Product Change Notification / SYST-16EQYH046

ERRATA - ATxmega128/64B3 Silicon Errata and Data Sheet Clarification Document Revision

ATxmega128/64B3

Silicon Errata and Data Sheet Clarification

Figure 3-1. ADC Overview

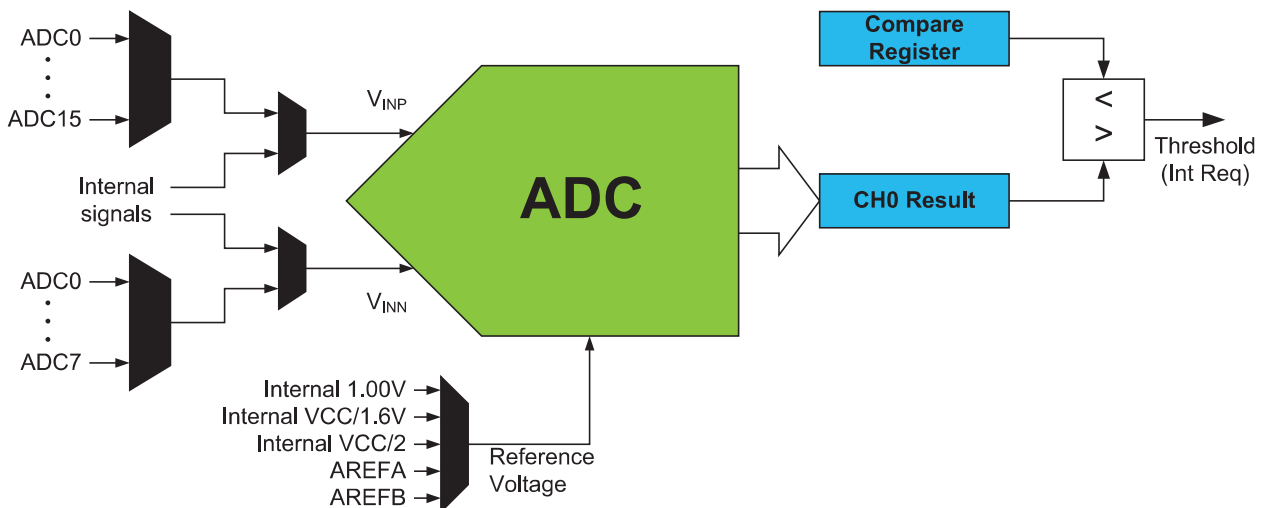
3.2 ADC – 12-bit Analog to Digital Converter

3.2.1 Overview

Note: After the ADC is enabled, the first sample may deviate from the expected result. It is recommended to discard the first sample or accumulate several samples.
